**PROPOSED CLOONMORE  
REGENERATION LRD ACCESS, CLOON  
MORE, TRALEE, COUNTY KERRY**  
**Stage 1 DMURS Road Safety Audit**

**Tulfarris CG Ltd.**

**August 2023**

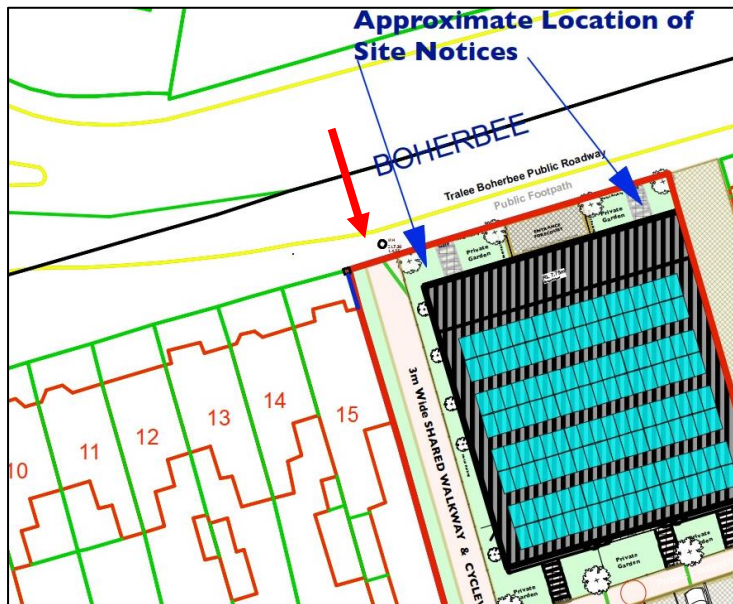
The existing Cloonmore Avenue footway at the Gaelcholáiste Chiarraí entrance is located on the east side of the school entrance, and on the inside (east) of the two-way off-carriageway cycleway, with no defined pedestrian crossing location at the school entrance. There is no footway along the south side of Cloonmore Avenue on the west side of the school entrance. There is no defined crossing location on Cloonmore Avenue, for pedestrians accessing between the school entrance and the proposed development site. There is an existing horizontal curve on Cloonmore Avenue, between the school entrance and proposed development site.

Although located outside the extent of the proposed access scheme presented for audit, the proposed residential development could generate school pupils and others accessing Gaelcholáiste Chiarraí as pedestrians. The proposed development shared walkway and cycleway would also facilitate access, through the proposed site, to and from Gaelcholáiste Chiarraí, further increasing pedestrian movements. Inadequate facilities for pedestrians could put them at risk of trips, falls and consequent injuries. Pedestrians could step out onto the road carriageway into the path of vehicles, putting them at risk of vehicle impacts and injuries. Pedestrians, including children, crossing Cloonmore Avenue at undefined locations could be at risk of vehicle impacts and injuries.

It is recommended that appropriate facilities and treatments should be provided on Cloonmore Avenue, in consultation with Kerry County Council, as appropriate, commensurate with expected user demand.

2.2	Yes	Yes	Audit Comment Only. Developer to provide drop kerb or other appropriate facilities and treatments on Cloonmore Avenue subject to agreement with KCC.

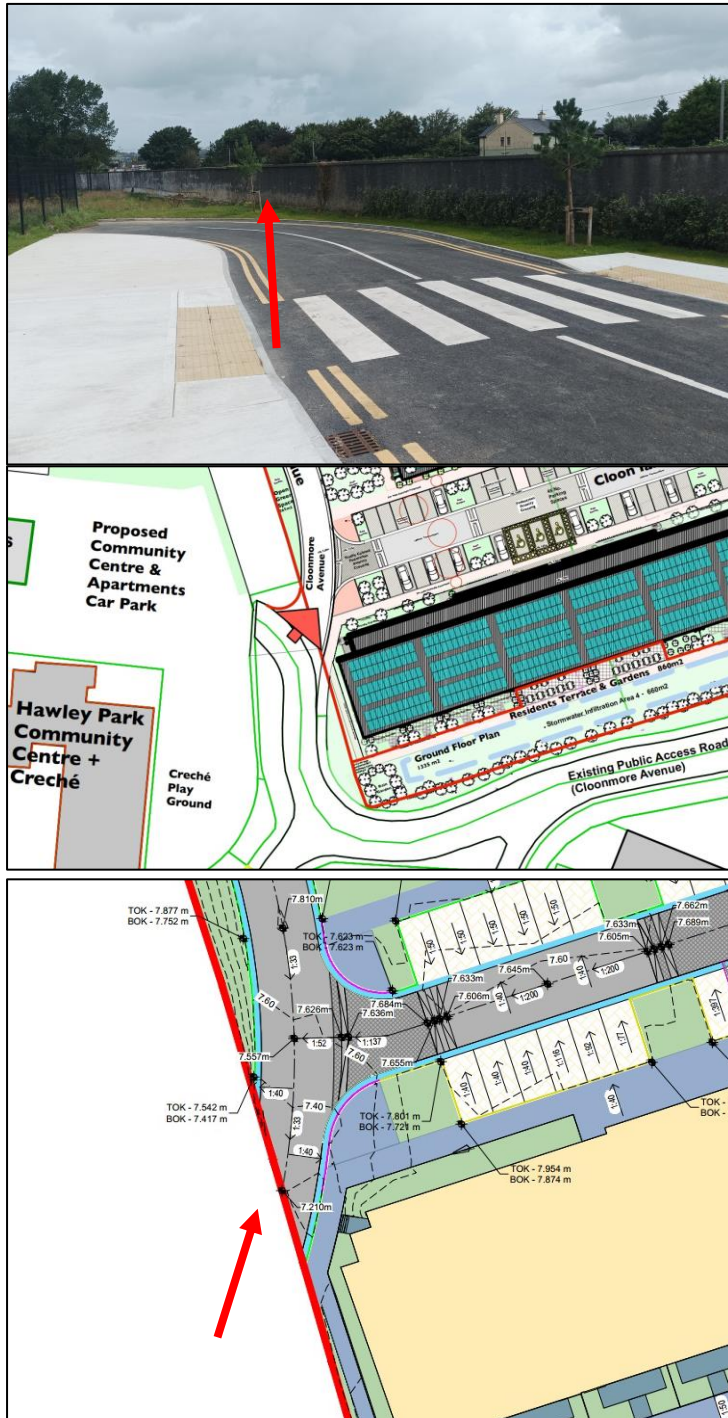
During the site inspection, a vehicle was parked on the Boherbee footway and footway buildout, immediately west of the proposed site; and located on the pedestrian desire line between the Zebra controlled pedestrian crossing at Boherbee Roundabout and the Boherbee footway. Vehicles parked on, and accessing, the footway could result in impact hazards and conflicts for pedestrians, including the mobility and visually impaired and pedestrians with children's buggies, putting them at risk of injuries. Pedestrians, including children, could step out onto the R875 road carriageway, putting them at risk of vehicle impacts and injuries.

Although located outside the extent of the proposed access scheme presented for audit, the proposed residential development would increase pedestrian movements along the Boherbee footway at this location. The proposed development shared walkway and cycleway would also facilitate access, through the proposed site, to and from Gaelcholáiste Chiarraí, further increasing pedestrian movements. It is recommended that Kerry County Council should provide appropriate treatments, such as bollards, to prevent parking on the existing footway.

2.4	Yes	Yes	Audit Comment Only. Appropriate treatments such as bollards to be implemented at the proposed pedestrian/cyclist entrance on Boherbee road subject to agreement with KCC.
